Technical Note TN22

29th September 2008

Instructions for upgrading 808 to 808.2 specification

**808i with left-hand
rear-panel and analogue
output card removed**

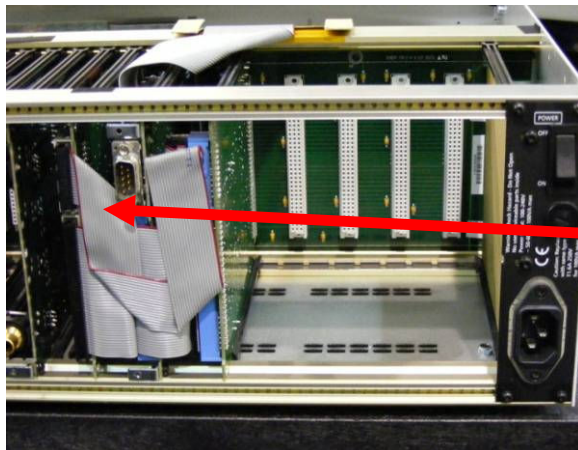
- c) Disconnect the 12-way loom from the CO00 card and remove the card. Remove the OE21 (digital output) card. These cards will not be re-installed, so they can be put to one side. As mentioned previously, be sure to ensure that the obsolete CO00 card is not confused with the new CO00 supplied with the upgrade kit.

- d) If the unit is an 808i, it will be fitted with IA00 and IE41 cards. These two cards can be left in their current positions.

Unit with right-hand rear-panel removed

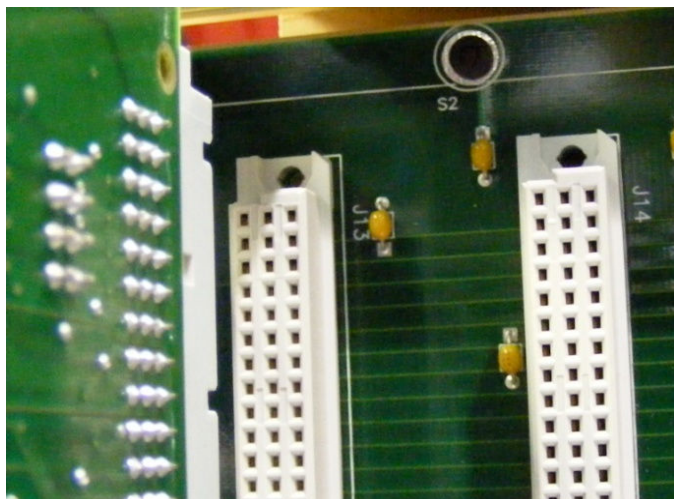
- e) Disconnect the two looms connecting together the cards either side of the DV02 card. Disconnect the wide “IDE” loom from the DV02 card. Remove all three cards.

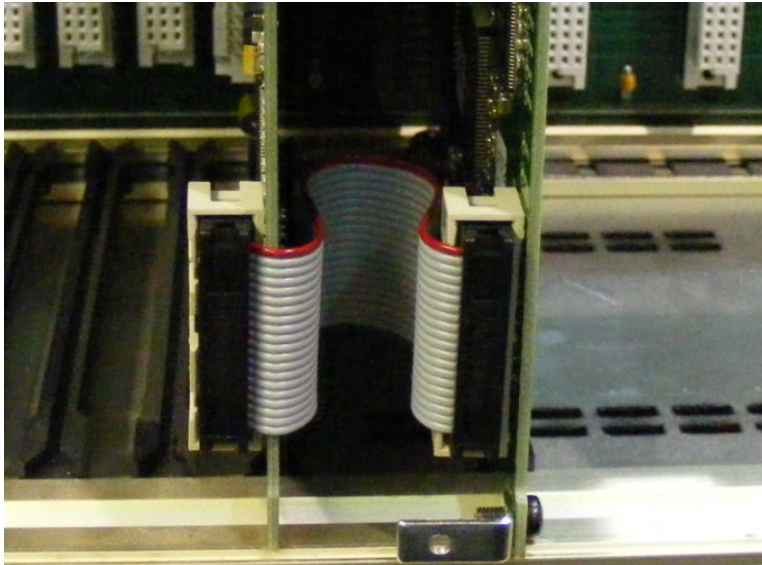
- a) Locate the socket which has “J13” printed to its right (as shown in the picture). Fit the DV08 card (SU0445) to this socket. Now, fit the wide “IDE” loom. Press the loom firmly home, ensuring that the securing hooks are positioned to hold the loom in place.

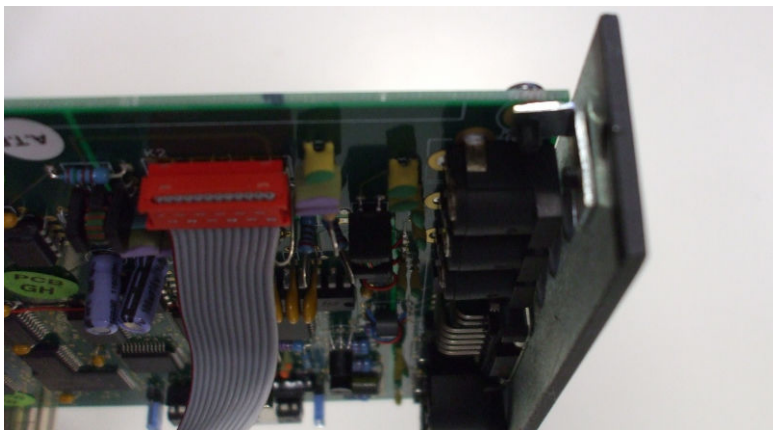
- b) Insert the DV28 card (SU0433) into socket “J12”. Connect the two cards using the 20-way loom supplied in the upgrade kit. It is important to fit this in the orientation shown here.

- c) Insert the OE28 card (SU0434) and the OA28 card (SU0432) into sockets “J11” and “J9” respectively.
- d) Insert the replacement CO00 card (SU) into the leftmost socket on the backplane and refit the 12-way loom that connects it to the display PCB. Ensure that the loom is fitted in the correct orientation as shown here.
